25 January 2018

Re: Development Application No. DA2017/1294 - Demolition works and the construction of a shop top housing development with ground floor car parking – 9 and 15 Lawrence Street, Freshwater

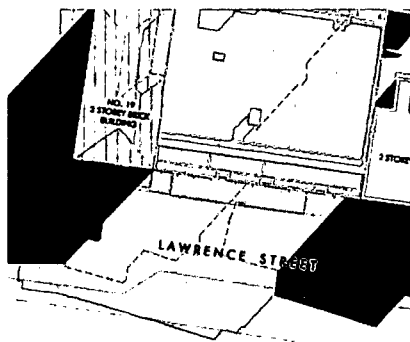
Whilst this may not be a breach of the Environmental Planning and Assessment Act 1979 (NSW), Council's notification map for both Development Applications indicates a significantly reduced area (only those directly adjoining) in comparison to similar developments of this size, scale and cost value in Lawrence Street (see notification map for DA2011/1361 and DA2012/1235). Council should note that a recent Development Application (DA2010/1446) for the site, was ultimately refused by the Land and Environment Court attracted some 1,953 submissions all opposing the development. For instance, residents/ratepayers of Undercliff Road, Albert Street, Moore Road, Dowling Street, Oliver Street and those surrounding were not included in the formal notification for DA2017/1287 and DA2017/1294 (E.g. As a resident within 50 meters of the development I was not formally notified by Council). By Council not providing notification to these neighbours and the Manly Daily's being infrequently circulated to these properties, would result in Council not undertaking its

adopted policy responsibilities to provide likely impacted residents the opportunity to raise their objections to these complex developments. It is therefore recommended that Council extend and expand re-notification of these applications prior to undertaking their assessment.

Shadow Diagrams for DA2017/1294 (Netteton Tribe dated 12.12.17)

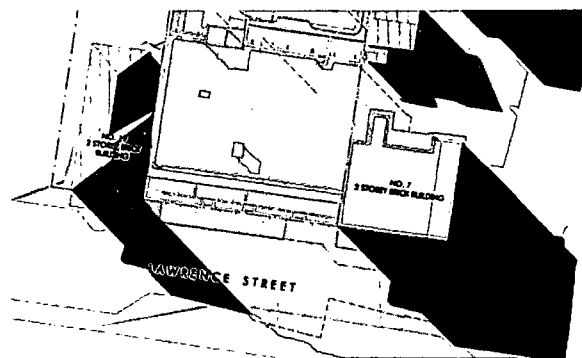
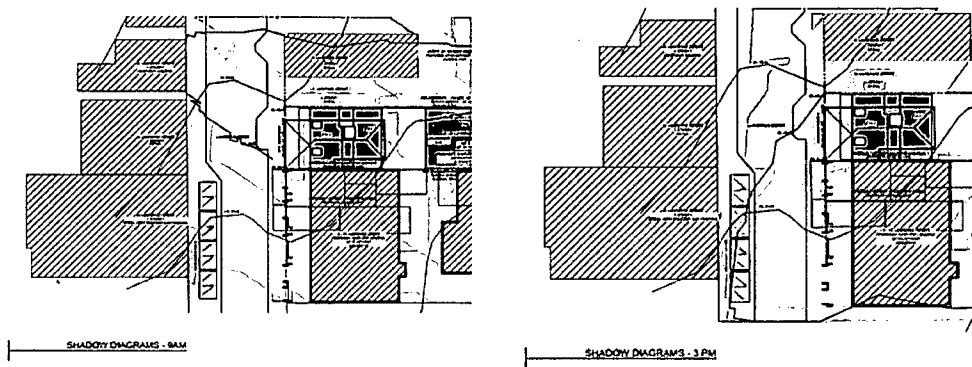
As a consequence of these non-compliances, there are also going to be adverse impacts of over and additional shadowing (highlighted in yellow) on Lawrence Street and particularly on the southern pedestrian pathway (public open space). Both shadow diagrams supplied appear to cut-off the shadowing on the boarder to the plans rather than indicating a true depiction of its impacts. It should be noted that D6 Access to Sunlight of the Warringah LEP 2011, refers to the planning principal *The Benevolent Society v Waverley Council [2010] NSWLEC 1082*. This makes reference to "Overshadowing arising out of poor design is not acceptable, even if it satisfies numerical guidelines. The poor quality of a proposal's design may be demonstrated by a more sensitive design that achieves the same amenity without substantial additional cost, while reducing the impact on neighbours".
